ITEM #6.2:	COMMITTEE OF ADJUSTMENT REPORT MINOR VARIANCE APPLICATION A236/22 43 Muzich Pl Woodbridge
-------------------	--

**COMMITTEE OF ADJUSTMENT REPORT
MINOR VARIANCE APPLICATION
A236/22
43 Muzich Pl Woodbridge**

ITEM NUMBER: 6.2	CITY WARD #: 3
APPLICANT:	Mauro Rossi (c/o Frank Loprieta)
AGENT:	Weston Consulting (c/o Kayly Robbins and Eleni Mermigas)
PROPERTY:	43 Muzich Place, Woodbridge
ZONING DESIGNATION:	See below.
VAUGHAN OFFICIAL PLAN (2010) DESIGNATION:	Vaughan Official Plan 2010 ('VOP 2010'): "Low-Rise Residential"
RELATED DEVELOPMENT APPLICATIONS:	B015/22, A236/22, A237/22
PURPOSE OF APPLICATION:	Relief from the Zoning By-law is being requested to permit reduced lot area on the severed land to facilitate Consent Application B015/22. Relief is also being requested to permit the construction of a proposed single family dwelling on the severed land and increased maximum driveway width.

File No.(s): B015/22, A236/22 & A237/22

SITE PLAN - PROPOSED

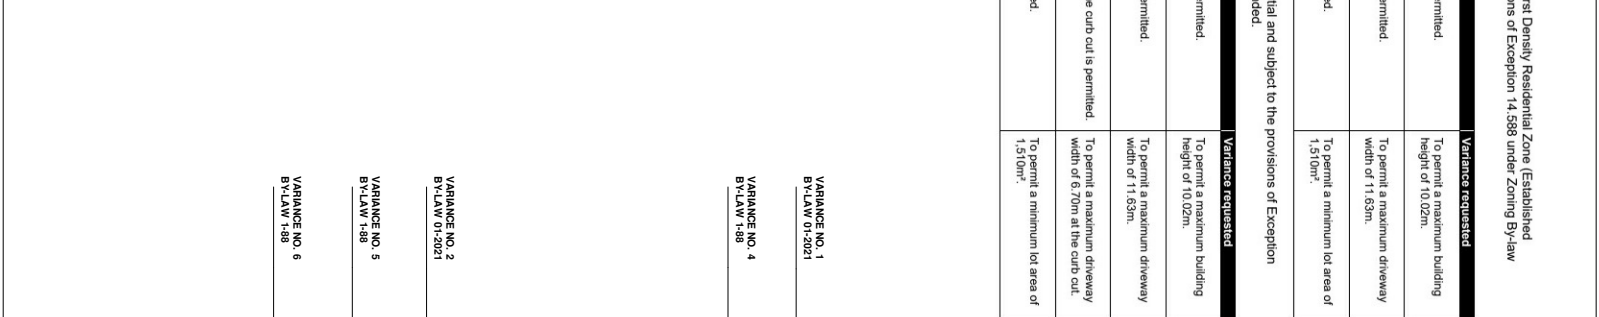
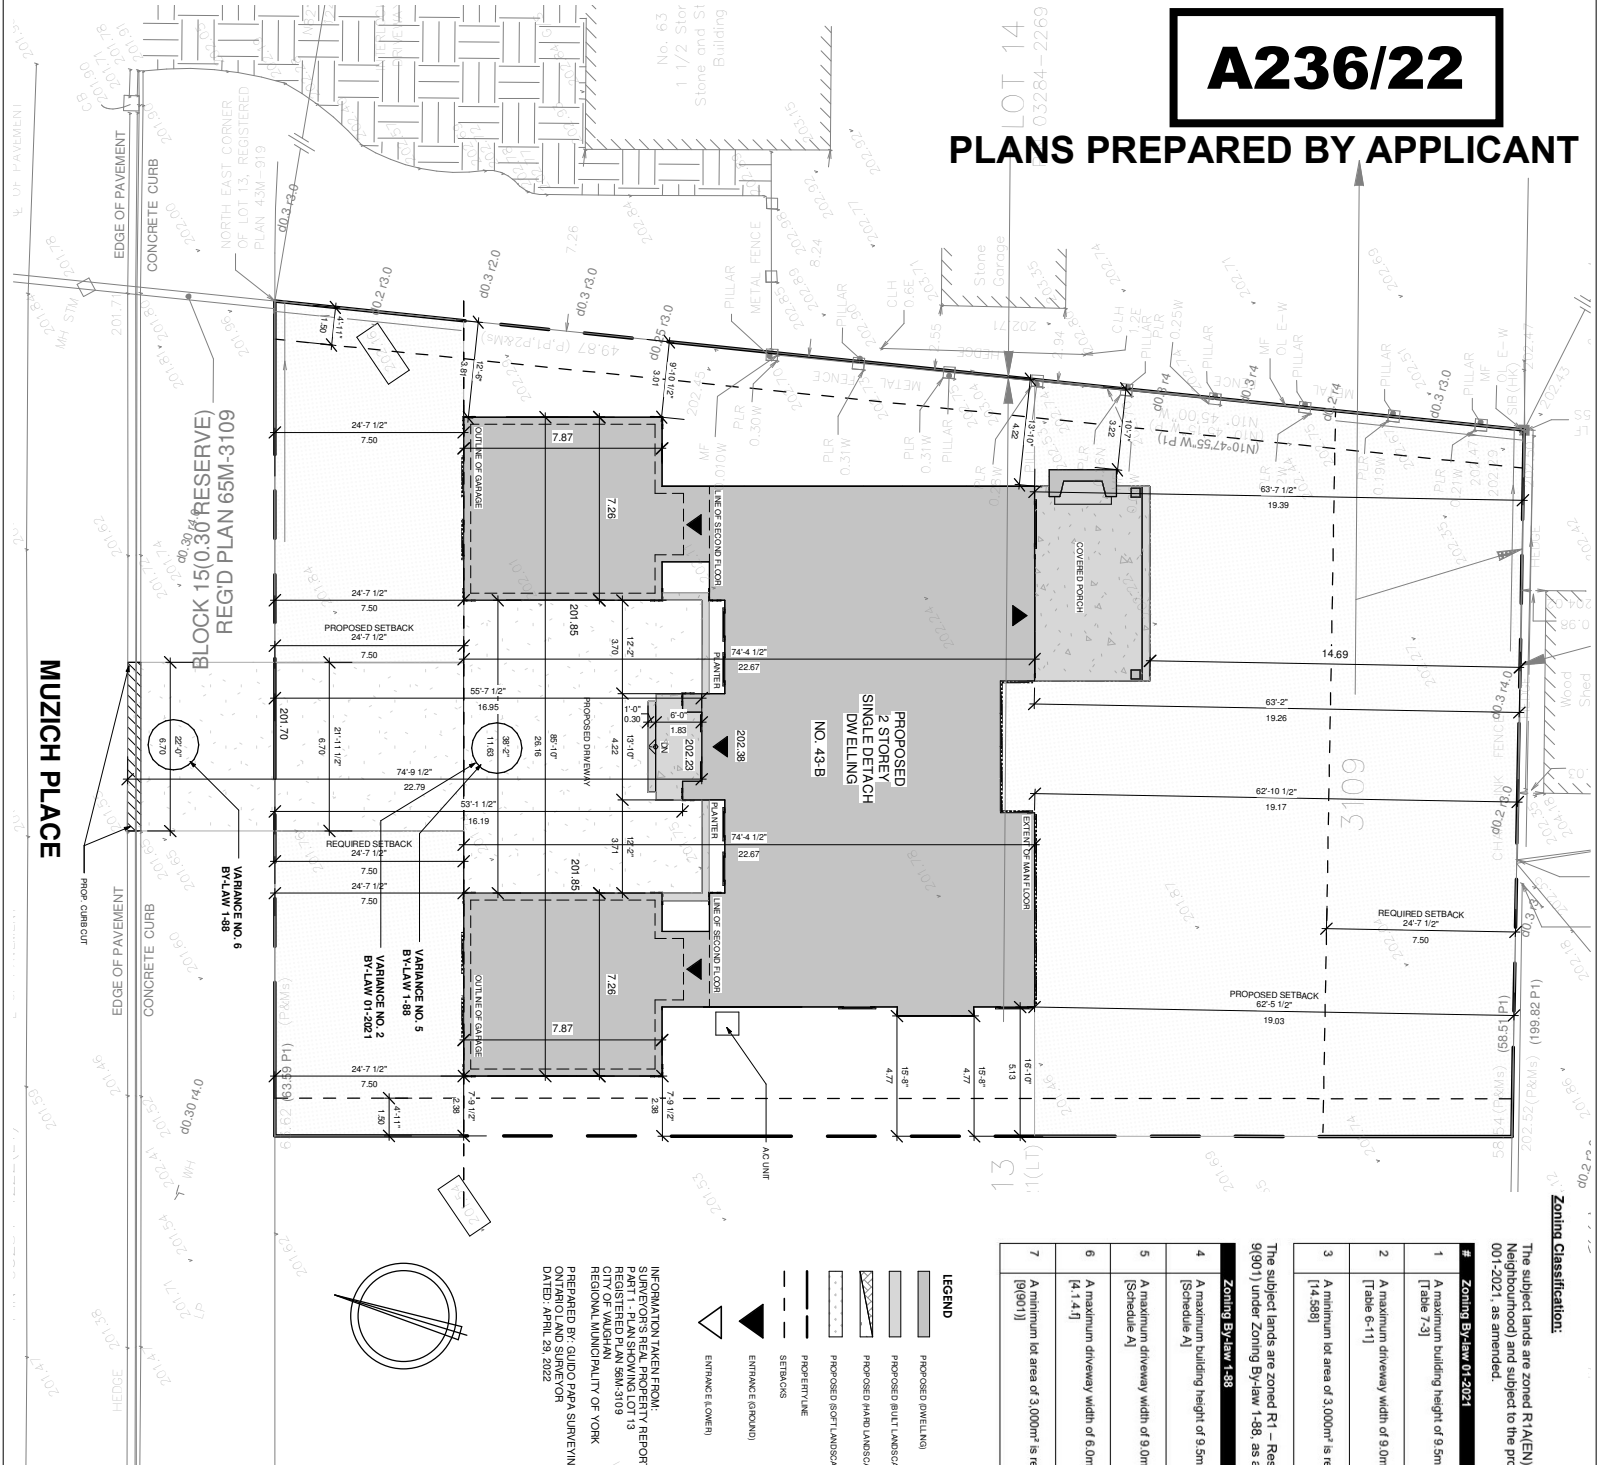
The Development Planning Department has no objection to Variances 2, 5 and 6 for the proposed 11.63 m driveway. The maximum driveway width is measured in between the two attached garages, which establish a courtyard-like appearance in front of the dwelling. The driveway width leading up to the courtyard is 6.7 m along its length and complies with Zoning By-law 001-2021, which was enacted by Vaughan Council on October 20, 2021, but has been appealed to the Ontario Land Tribunal and is not in effect.
